PG&E Letter DCL-22-018
PG&E Letter DIL-22-007

Diablo Canyon Units 1 and 2
Docket No. 50-275, OL-DPR-80
Docket No. 50-323, OL-DPR-82
Docket No. 72-26, Materials License No. SNM-2511
Diablo Canyon Independent Spent Fuel Storage Installation
Responses to NRC Requests for Additional Information on “License Amendment Request 21-04, Proposed Changes to the Diablo Canyon Power Plant Emergency Plan for Post-Shutdown and Permanently Defueled Condition”

Responses to NRC Request for additional information – Diablo Canyon proposed changes to emergency plan for post-shutdown and permanently defueled condition (EPID: L-2021-LLA-0190)

5.22 FIGURE 5-2, TSC ORGANIZATION

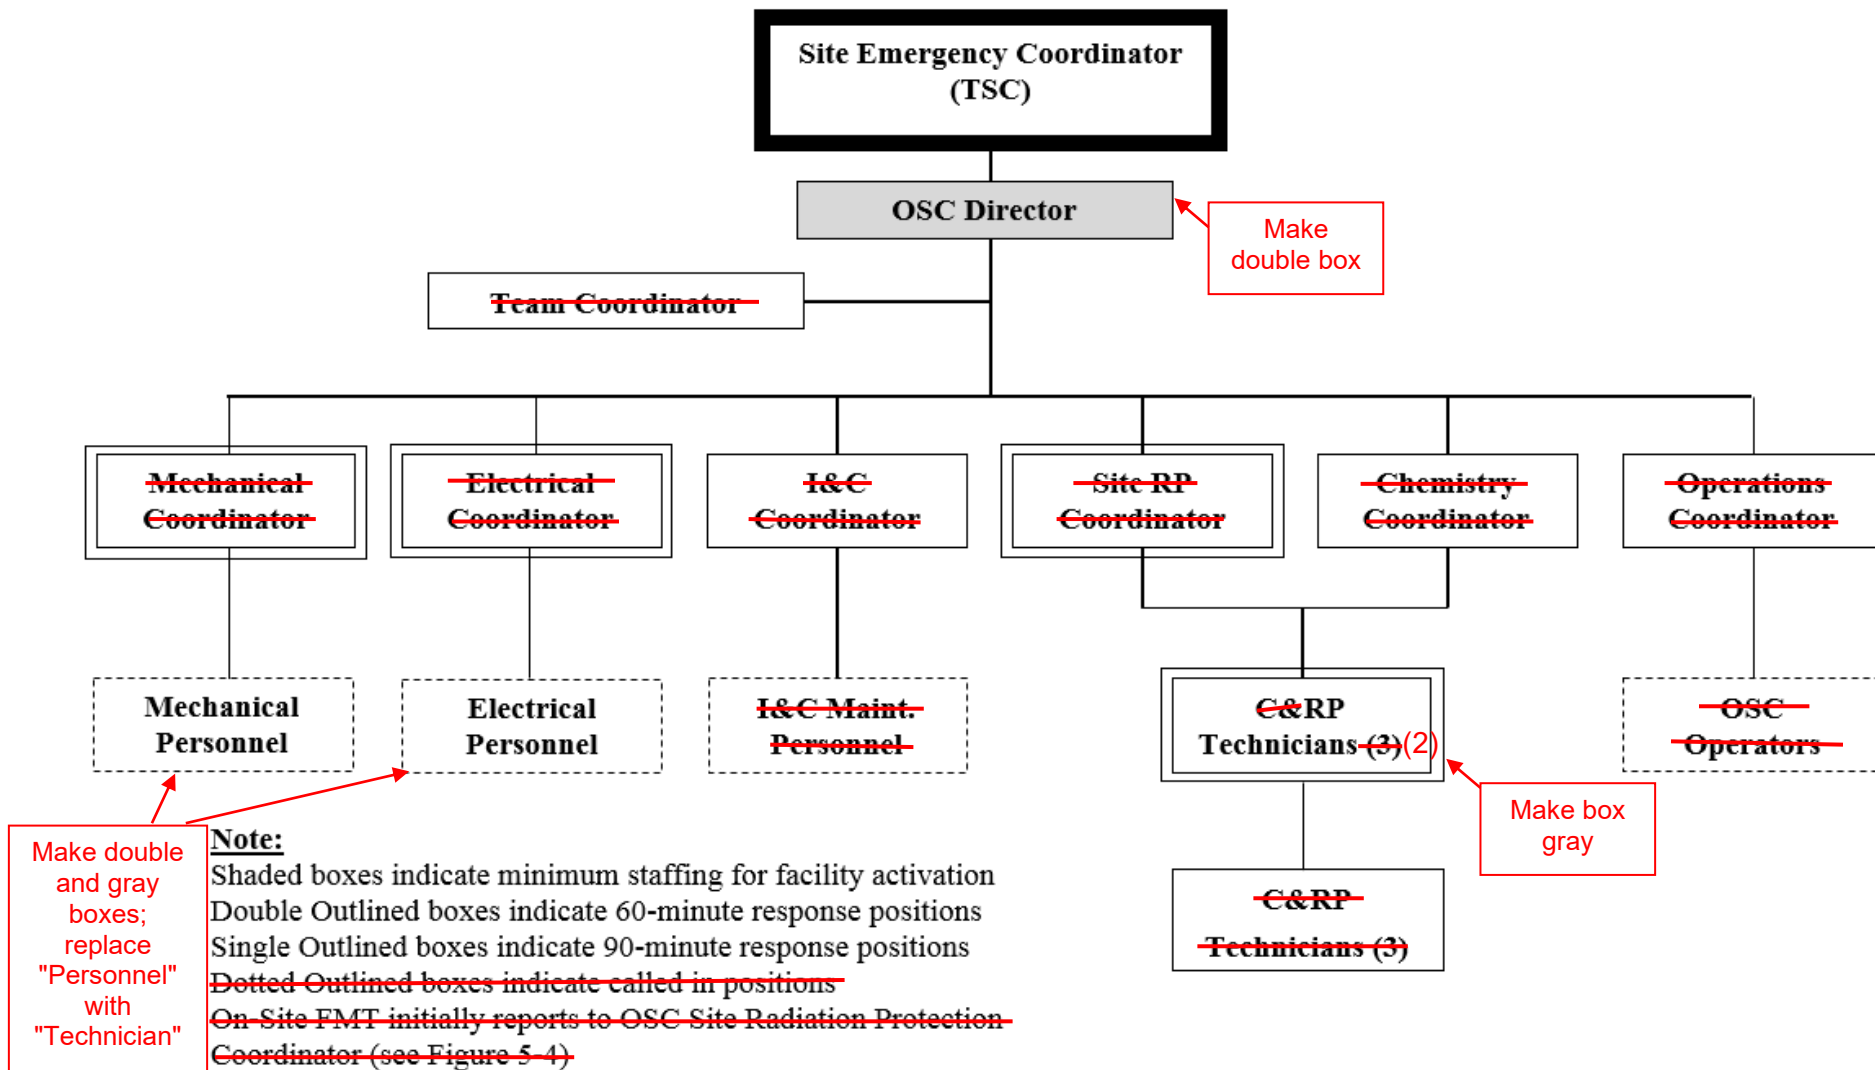
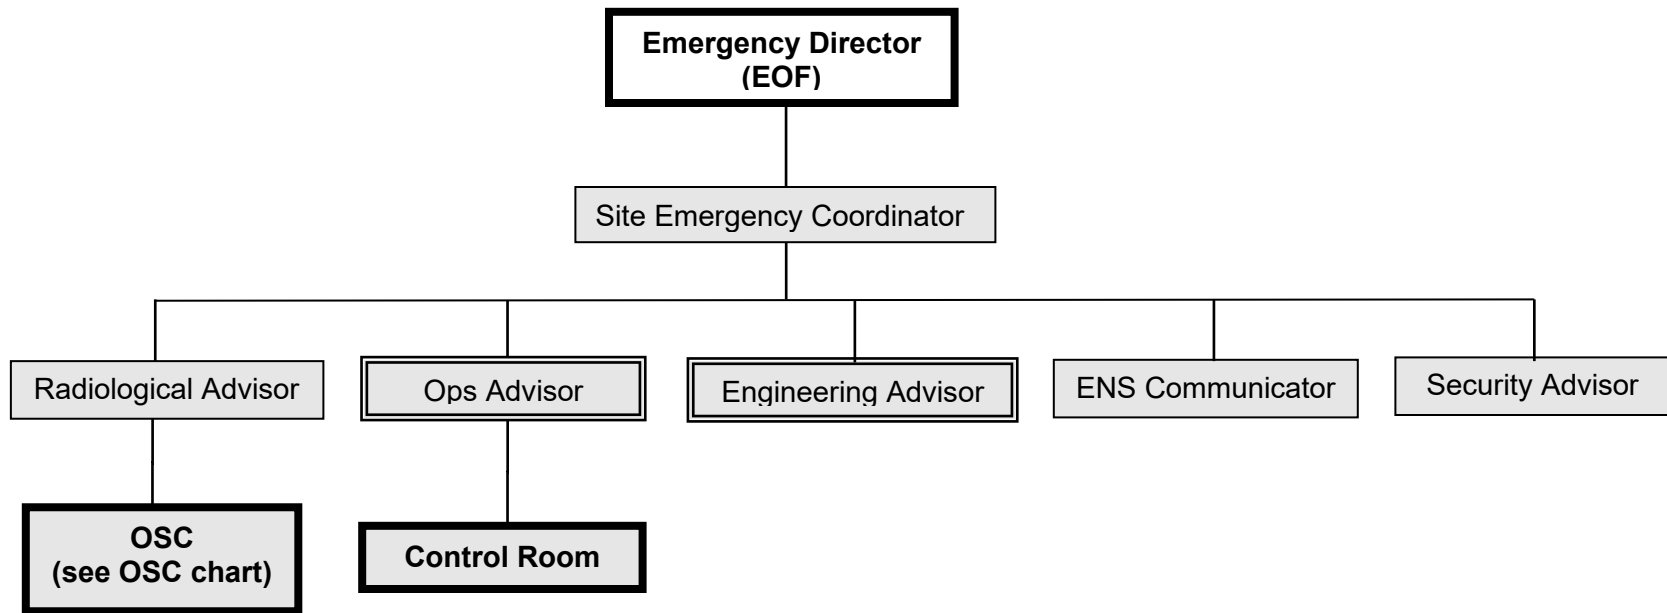
RAI-1

As proposed, the minimum engineering staffing will not allow the facilities to perform the intended functions within 60 minutes (e.g., Plant System Engineering is provided by the TSC Engineering Advisor with a 90-minute response).

Describe how the augmented engineering staffing will continue to be aligned with the current DCPD E-Plan to ensure the continued effective and timely implementation of the major task of Technical Support/Accident Analysis within 60 minutes of the declaration of an Alert or higher ECL.

To ensure the continued effective and timely implementation of the major task of Technical Support/Accident Analysis, the proposed Diablo Canyon Power Plant (DCPP) Emergency Plan (E-Plan) is revised to designate the Technical Support Center (TSC) Engineering Advisor as a minimum staff 60-minute responder (i.e., within 60 minutes of the declaration of an Alert or higher emergency classification level [ECL]).

Qualifications for the TSC Engineering Advisor position selection criteria will align with the current position requirements. As discussed in Enclosure 1, Section 5.2.5a of the license amendment request, the Attachment 4 Task Analysis concluded that all of the TSC Engineers' responsibilities and tasks can be eliminated. As such, no new tasks are being added to the TSC Engineering Advisor position and the Engineering function will continue to be maintained by the TSC Engineering Advisor without competing priorities. Revised DCPP E-Plan, Sections 5.19 and 5.22, markup and clean pages are provided in the Attachments of this Enclosure to reflect this change.

5.23 FIGURE 5-3, OSC ORGANIZATION

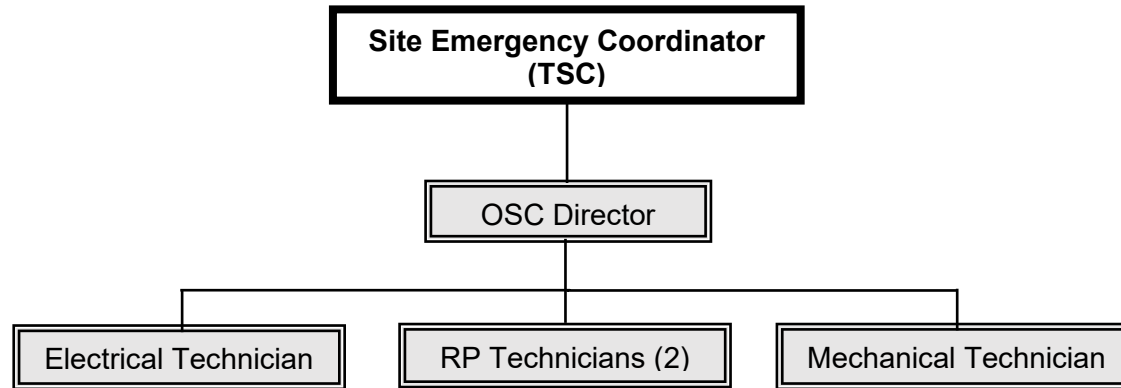
As proposed, the minimum maintenance staffing will not allow the facilities to perform the intended functions within 60 minutes (e.g., maintenance support is provided by the OSC Director with a 90-minute response with Mechanical Maintenance and Electrical/Instrumentation and Controls (I&C) Maintenance positions called-in as needed to support repair and corrective actions).

Describe how the augmented maintenance staffing will continue to be aligned with the current DCPP E-Plan to ensure the continued effective and timely implementation of the major task of Repair and Corrective Actions within 60 minutes of the declaration of an Alert or higher ECL.

To ensure the continued effective and timely implementation of the major task of Repair and Corrective Actions, the proposed DCPP E-Plan is revised to maintain the Operations Support Center (OSC) Director as a minimum staff 60-minute responder (i.e., within 60 minutes of the declaration of an Alert or higher ECL). In addition, one qualified Mechanical Maintenance technician and one qualified Electrical Maintenance technician will be minimum staff 60-minute OSC responders. Revised DCPP E-Plan, Sections 5.7.3, 5.19, 5.20, and 5.23, markup and clean pages are provided in the Attachments of this Enclosure to reflect these changes.
